SERVICE INFORMATION BULLETIN

APPLICABILITY: 2015-19MY WRX and WRX STI

NUMBER: 12-264-19

SUBJECT: Child Anchor Retaining Bolt- Design Change

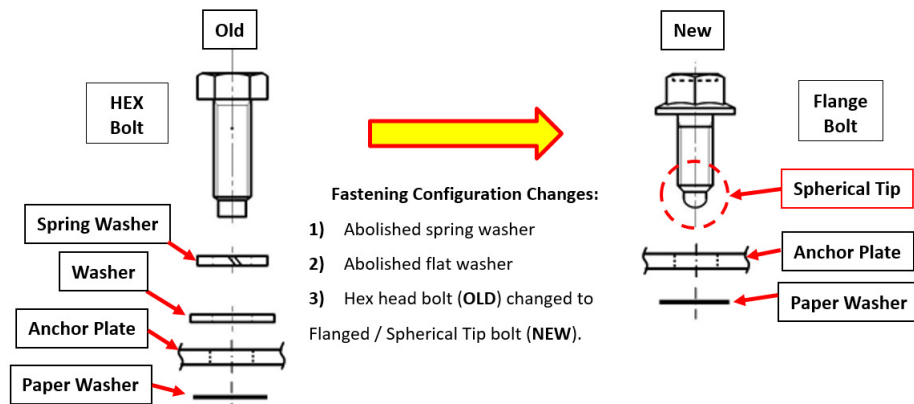
This Service Information bulletin announces a design change made to the retaining bolt used to secure the child anchors to the rear shelf plates on the models listed above. This change was made in support of parts communization with other similar mounting bolts. There is no change between the old and new bolt in terms of function or durability.

The part number for the new FLANGE BOLT is: **901000473**.

NOTE: The torque specification for the new Flange Bolt is: **25 Nm (18.4 ft. lbs.)**.
